Earth Science Engineering, P.C.

Re: Black Ash Pond: Environmental Restoration Project, E516009 Response to SI/RAR Workplan Review

We have completed a review of your comment letter dated August 2, 2004 regarding the referenced project. We respectfully submit the following revisions, supplements and modifications to our July 2004 Workplan. Consistent with our previous conversation, we intend to finalize this letter document with you so that it may serve as an addendum to the referenced project Workplan.

FIGURE 1 **SITE LOCATION MAP** (Revised 8/24/04)

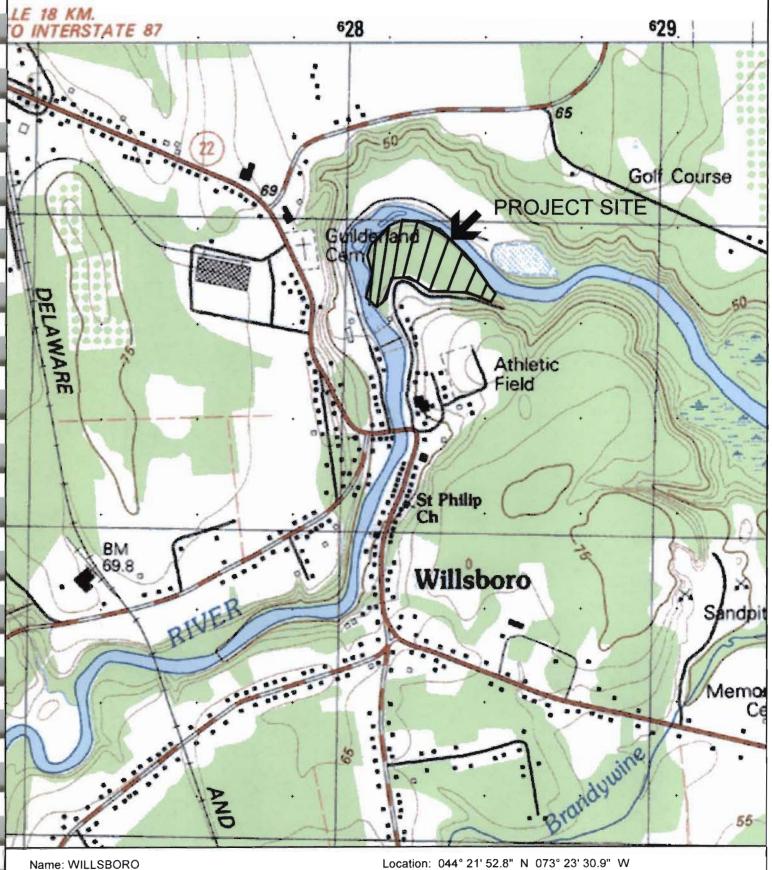
- Figure 1 revised to emphasize the 25-acre site.
- Skull and cross bone designations deleted.
- Figure 2 revised to specifically differentiate on and off-site sampling.
- Figure 2 revised to include road, boat launch, and nearby buildings.
- Figure 2 revised to include all symbols in legend.
- Figure 2 revised to include approximate scale and north arrow.

SITE PLAN (Revised 8/24/04)

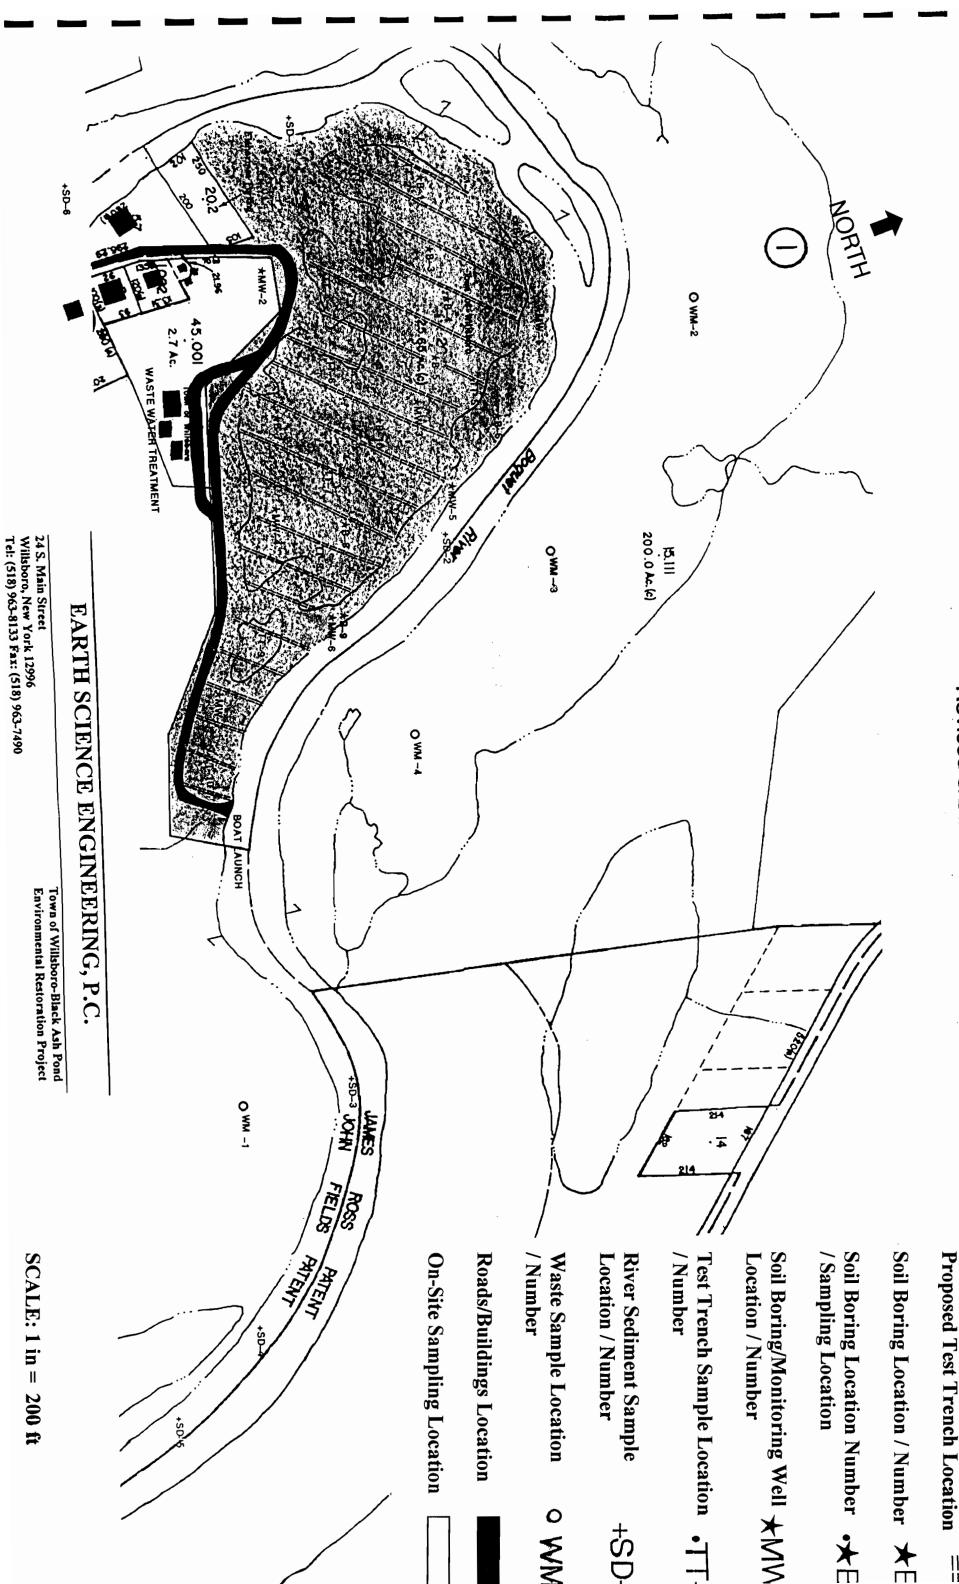
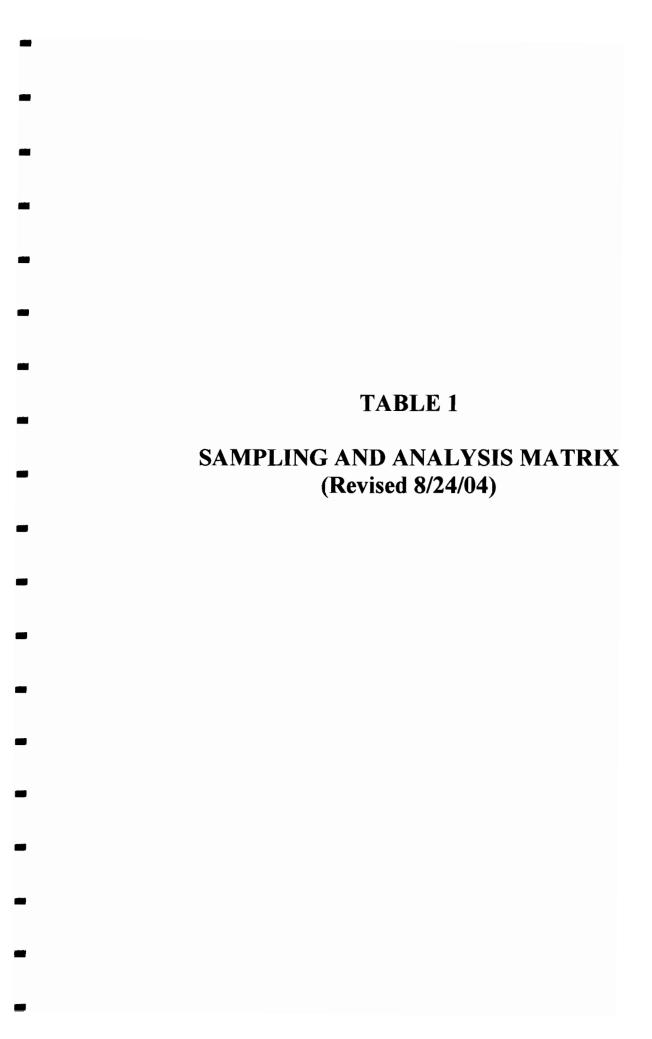
River sediment samples will be collected from a total of two (2) upstream locations and four downstream locations. Upstream sediment sampling locations will include one remote upstream location (upstream of the existing dam) and one location slightly upstream of the Black Ash Pond. The six (6) total upstream and downstream river sediment sampling locations have been revised and are shown in Figure 2.

As part of the groundwater investigation task, the number of shallow groundwater monitoring wells to be installed will be increased from five (5) to seven (7). As shown on Figure 2 (Revised), additional monitoring wells will be installed at the boring B-9 location (MW-6) and at a supplemental boring location completed in between test trenches TT-9 and TT-10 (MW-7).
